RULE NO.: R161-18.17

NOTICE OF PROPOSED RULE

R161-18.17: Proposed revision to the Standard Details 506

CITY OF AUSTIN AUSTIN WATER	WEDGE - SEAL JOINT DETAIL PRECAST MANHOLE SECTION	
DRAFT 04/11/2018 ADOPTED	THE ARCHITECT/ENGINEER ASSUMES RESPONSIBILITY FOR APPROPRIATE USE OF THIS STANDARD.	STANDARD NO. 506-AW-13 1 OF 1

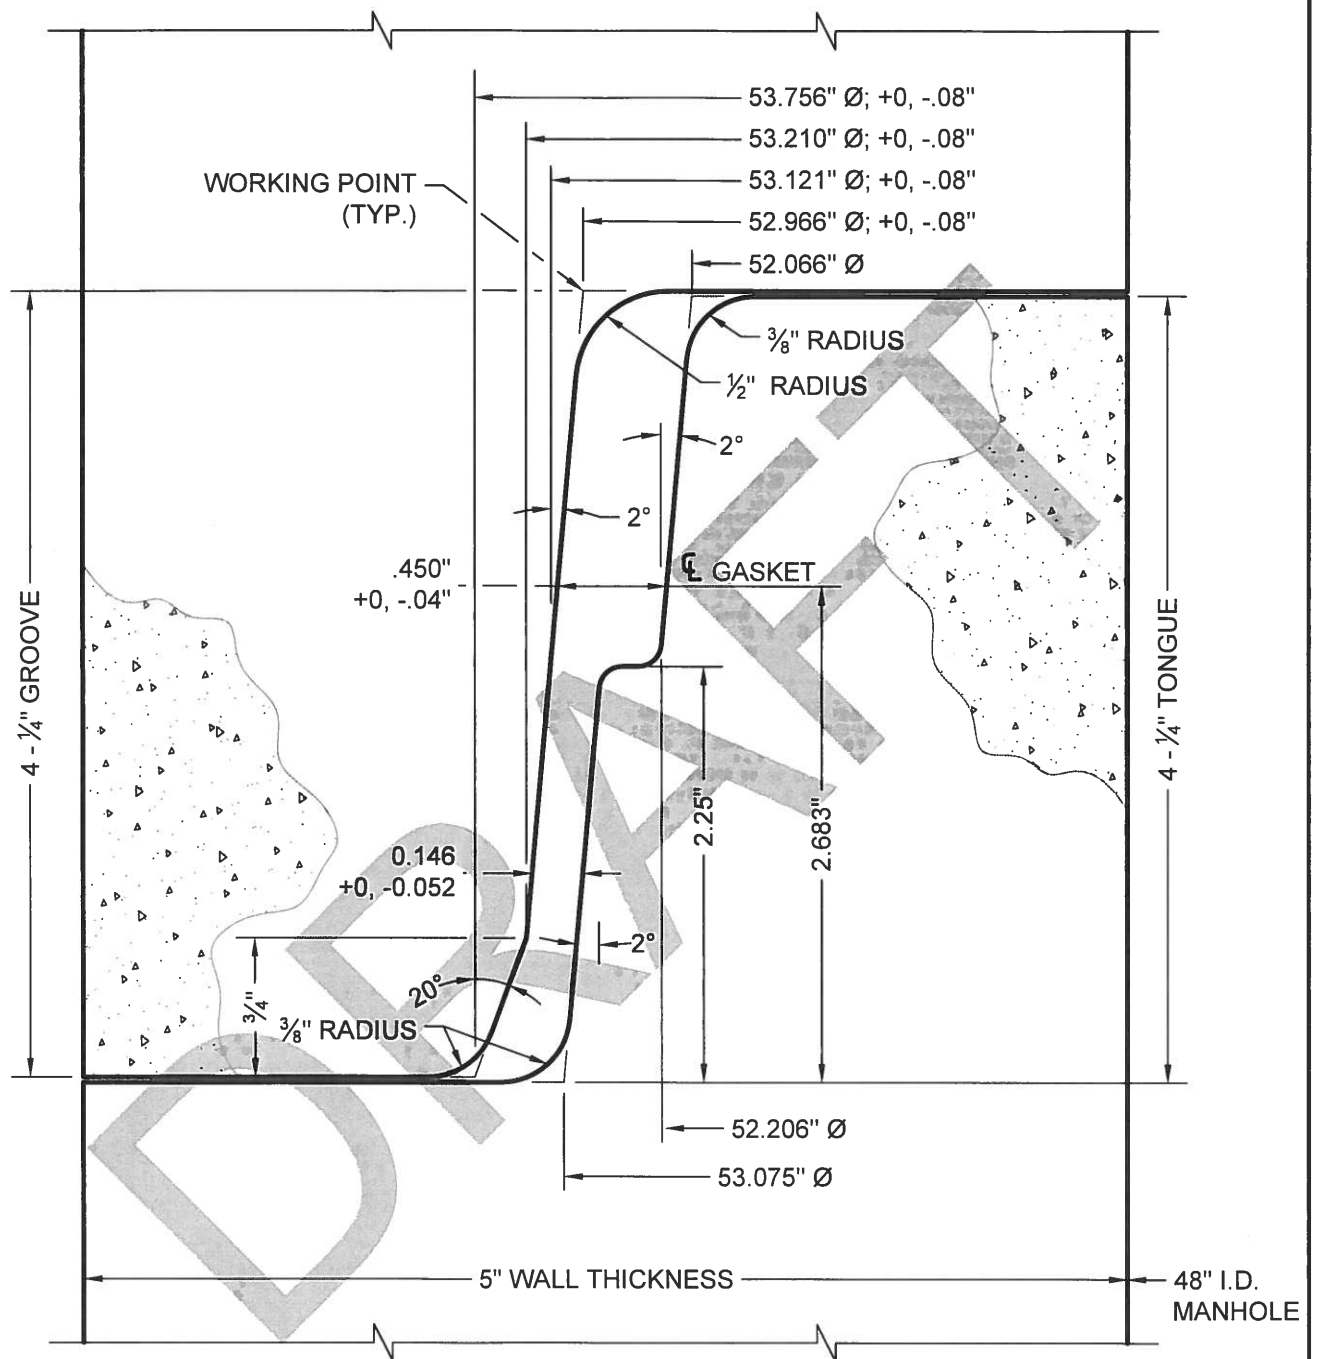
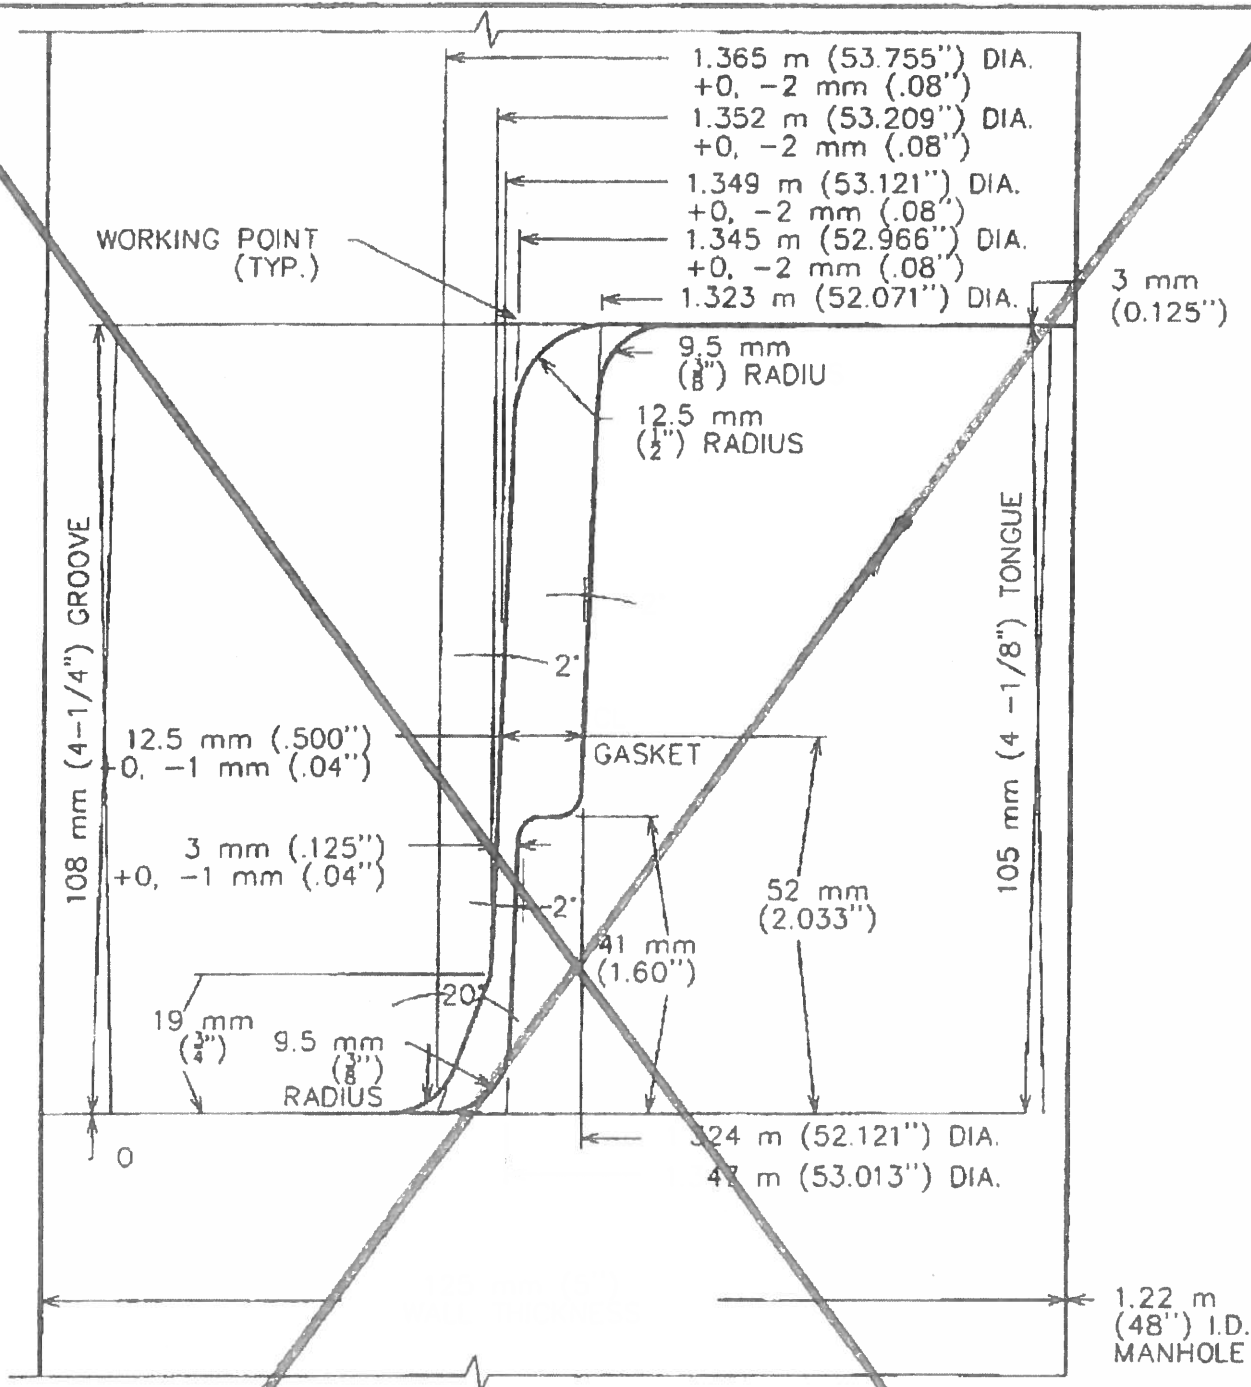
- Standard Detail 506-AW-13 – This detail is being created to replace the Standard Detail 506S-13. The reason for the change is to correct an error in the dimensions of Standard Detail 506S-13 to match the industry standard.
- Standard Detail 506S-13 Removal – This detail being removed and replaced with Standard Detail 506-AW-13.
